Washington State Regional Haze State Implementation Plan

Appendix B

Federal Land Managers Comments and Ecology's Response to Comments

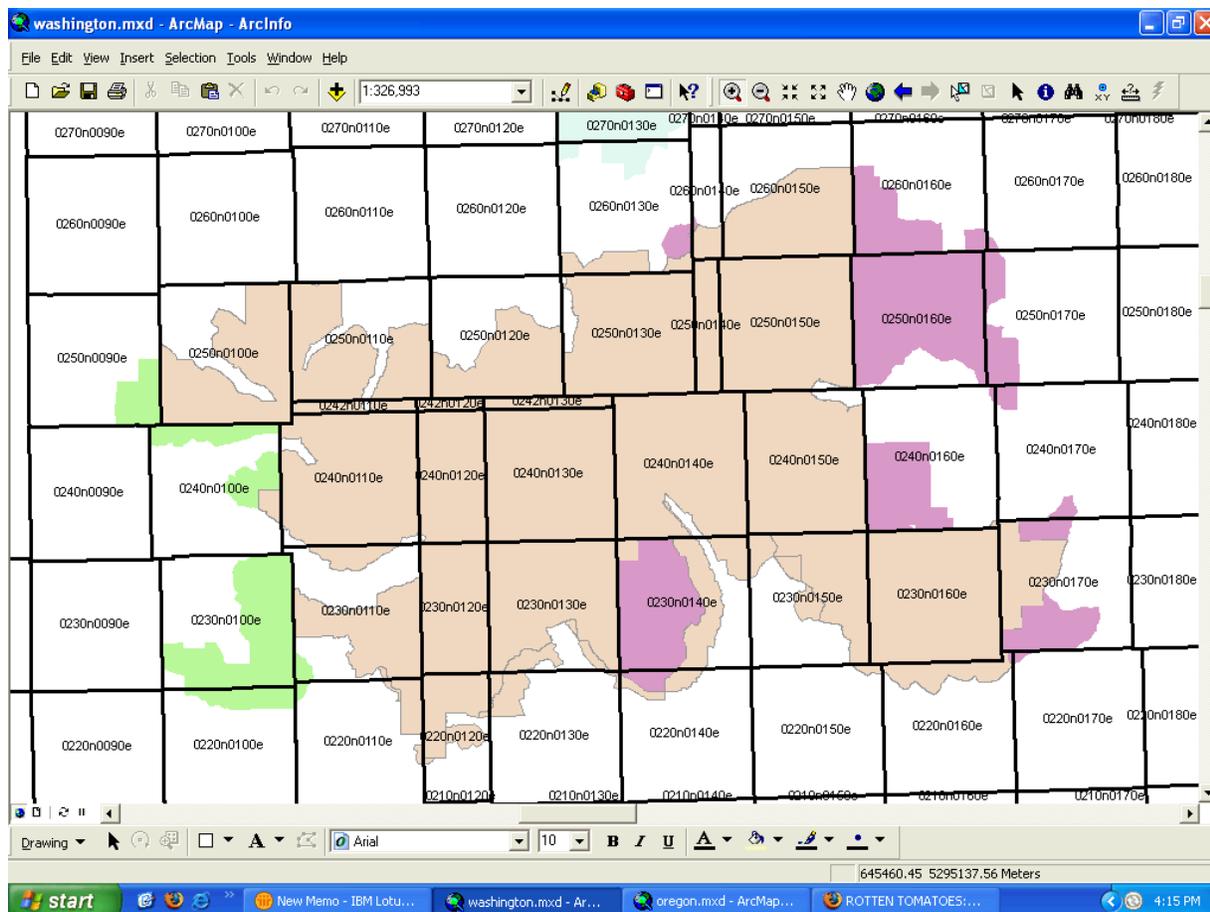
The USDA-FS notes that there is an incorrect sentence in Chapter 4 and the map of the Alpine lakes wilderness in Figure 4-4 is incorrect and provides Ecology with an updated map for use.

The map you are using for Alpine Lakes wilderness is incorrect (Figure 4-4). Below is the correct extent of the wilderness. We will be happy to assist you in getting the correct boundaries for this wilderness.

Ecology has removed the questioned sentence from Chapter 4. We revised Figures 4-1 and 11-1 showing the boundaries of the Alpine Lakes Wilderness. Figure 4-4 is from Causes of Haze Assessment Descriptive Maps and we are unable to revise this figure.
